N° 2015-086-A

Implementation of 300mm wafer diameter, capacity extension and conversion to halogen free mold compound for selected 600V C6 CoolMOS<sup>TM</sup> DPAK/IPAK products.

#### N° 2015-086-A

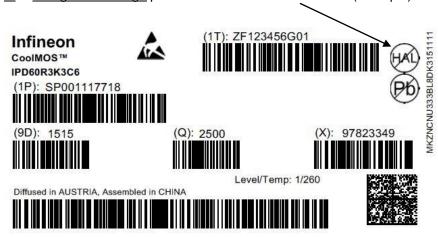
- <u>Internal traceability:</u> assured via baunumber, lot number and date code
- <u>2.</u> <u>External traceability:</u> new SP number for Halogen free products.
- 3. Lotnumber printed on Barcode Product Label:

VExxxxxx = IFX Villach, 200mm production

1Exxxxxx = IFX Kulim, 200mm production

2Fxxxxxx = IFX Dresden, 300mm production

VFxxxxxx = IFX Villach, 300mm production
